ADDENDUM NO. 3

IRVINE VALLEY COLLEGE GREAT LAWN

JULY 30, 2010

BID DOCUMENT CLARIFICATION NARRATIVE

PROJECT: GREAT LAWN STAGE LAYOUT		SKETCH:
ADD #: ADDENDUM 3	SUBJECT: ADDENDUM 2	ISK-1
CITY: IRVINE	SHEET NAME: IRRIGATION PLAN	
DESCRIPTION: REVISED IRRIGATION PLAN AT STAGE AREA	PROJECT #: 713-09	REVISION #:
	DATE: 07/26/10	SHEET #: L-2.01
		 RJM DESIGN GROUP, INC.

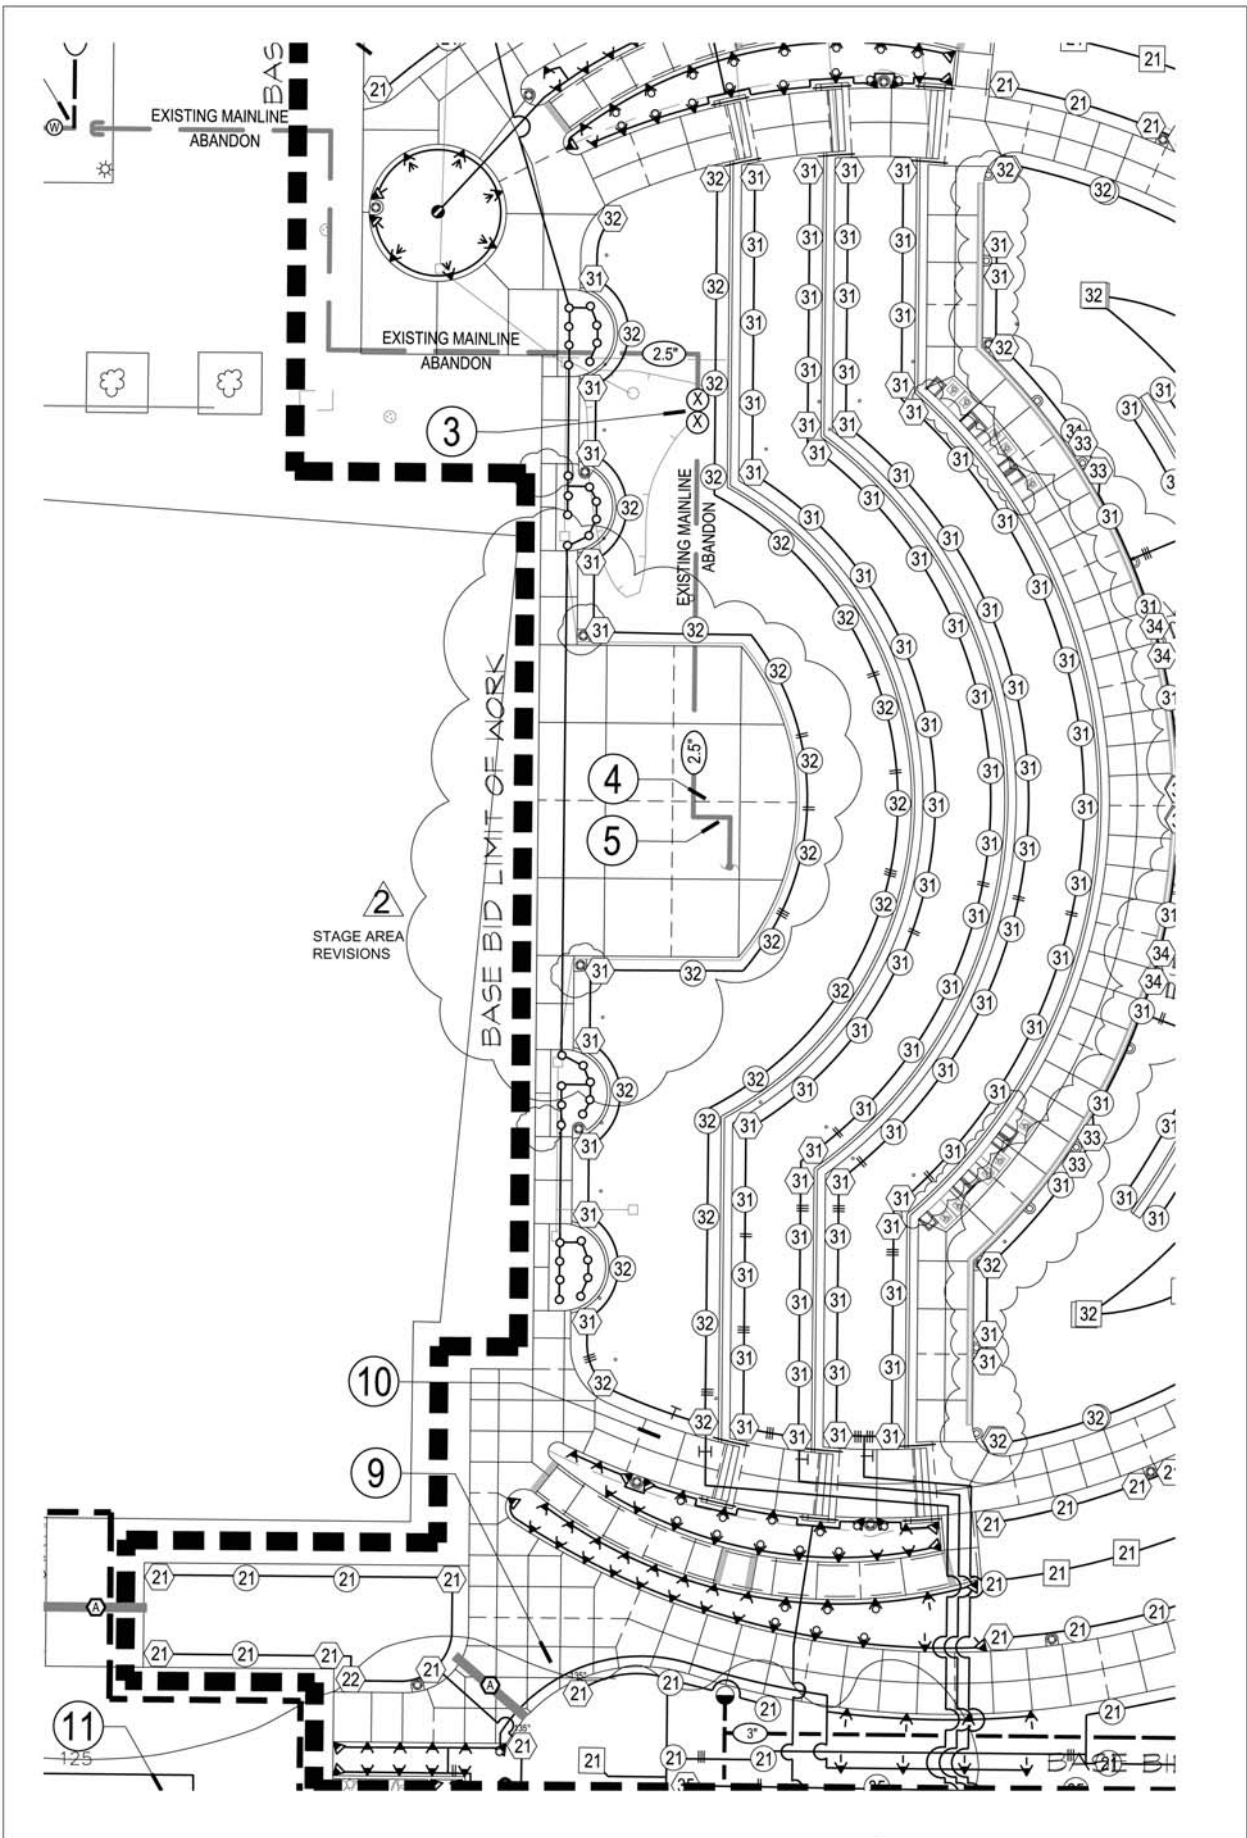
1. Irrigation plan at stage area has been modified. See sketch ISK-1 (Irrigation Plan L-2.01).
